NAVIGATION - XM WEATHER RECEIVER UPDATE

MODEL	SERIAL NUMBERS
525C (CJ4)	-0001 thru -0358 equipped with an XMWR-1000 Receiver

SB525C-34-15
Page 1 of 8

Figure 1. XM Weather Receiver Removal/installation (Sheet 1)

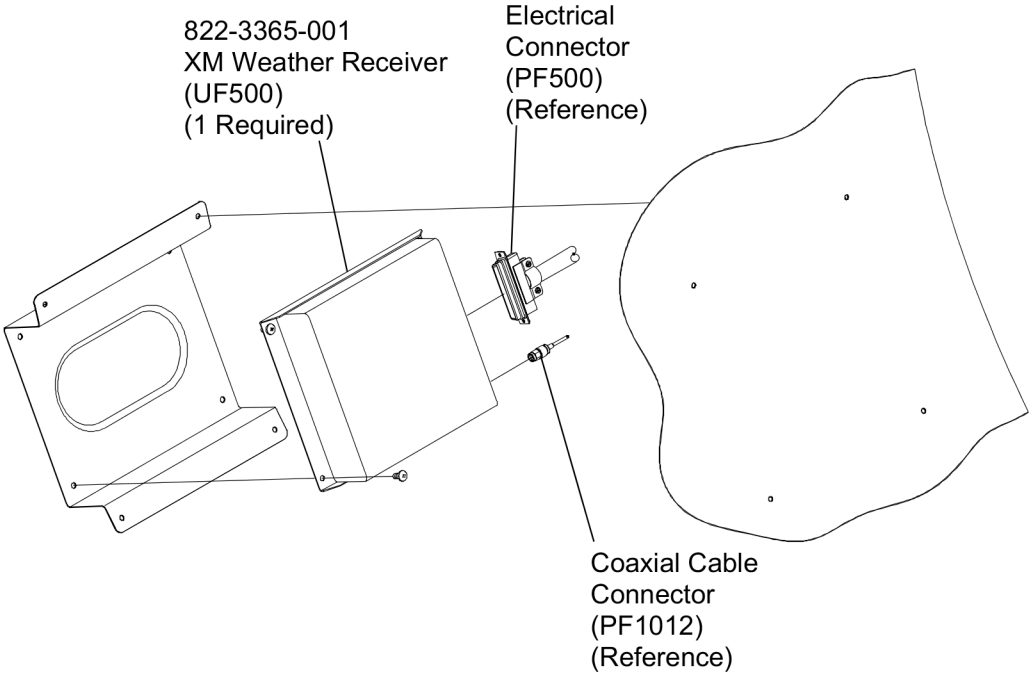
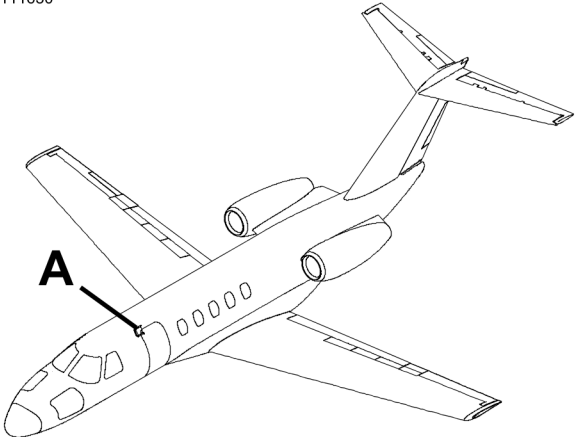
3. Remove the current 822-2031-002 XM Weather Receiver and return it to Textron Aviation for exchange. (Refer to the Model 525C Maintenance Manual, Chapter 34, XM Receiver - Removal/Installation.)

4. Install the new 822-3365-001 XM Weather Receiver. (Refer to the Model 525C Maintenance Manual, Chapter 34, XM Receiver - Removal/Installation.)
5. Connect the airplane battery.
